Title 842 RADIO RECEIVER		COMPUTIME LTD. 1/F, 99 HOW KING ST., KOWLOON HONG KONG	
Designed by:		Drawn by:	
Size: A4	Number:	Revision: 1	Date: 19-Jul-2000 Time: 13:20:21 Sheet 1 of 1
File: E:\My Documents\842\842_2.sch

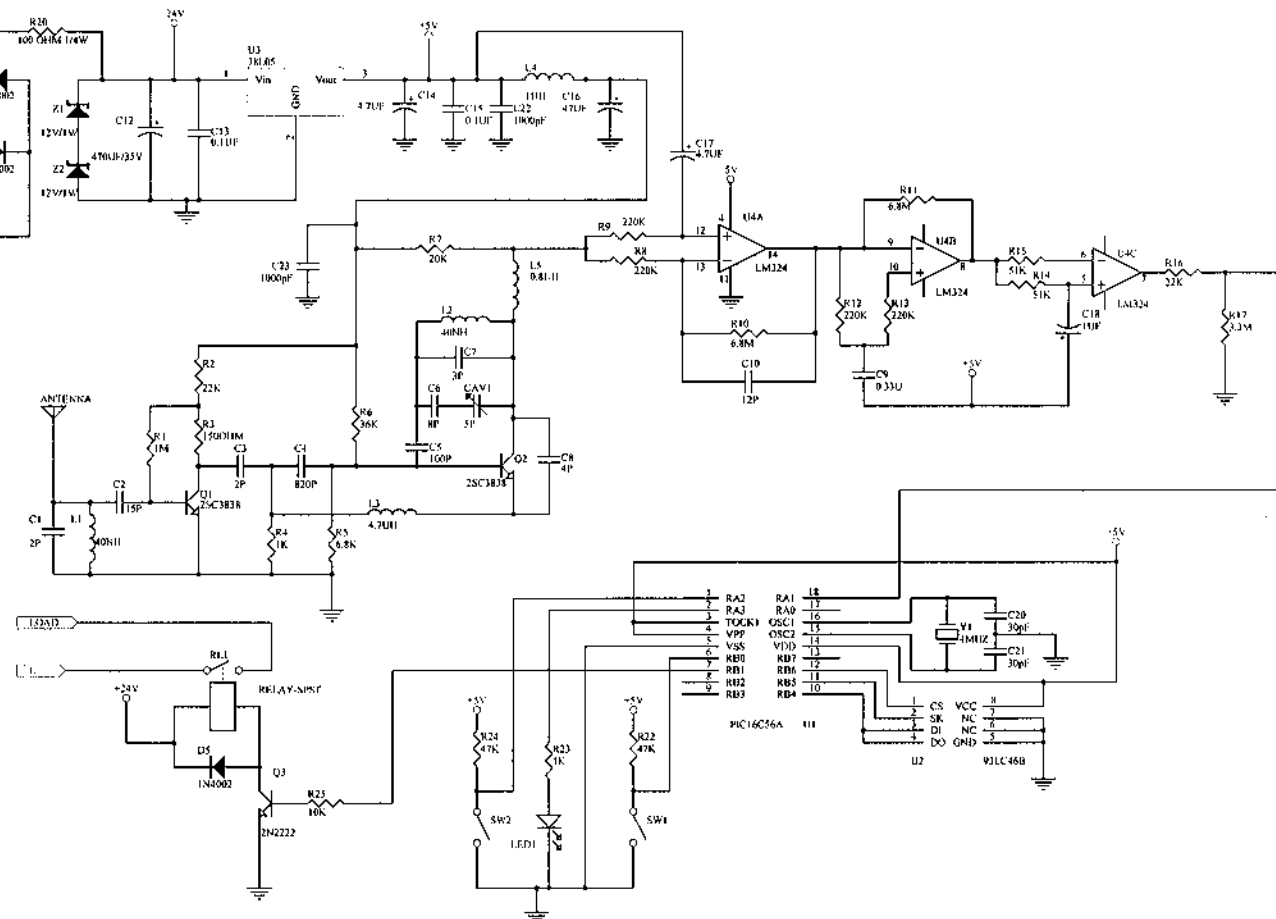
Changes:
15/5/2000

1. C3 was 30nF, now 2pF
2. C5 was 150pF, now 100pF
3. R6 was 33K, now 36K
4. C7 was 2pF, now 3pF
5. C8 was 6pF, now 8pF
6. C8 was 3pF, now 4pF
7. Add C22, C23, both 1000pF.

Changes:
13/3/2000

1. C7 was 4pF, now 2pF
2. C8 was 1pF, now 3pF
3. C10 was 7pF, now 12pF
4. R4 was 1.5K, now 1K
5. R7 was 15K, now 20K
6. R10 was 3.3K, now 6.8K
7. L5 was 1uH, NOW 0.8uH
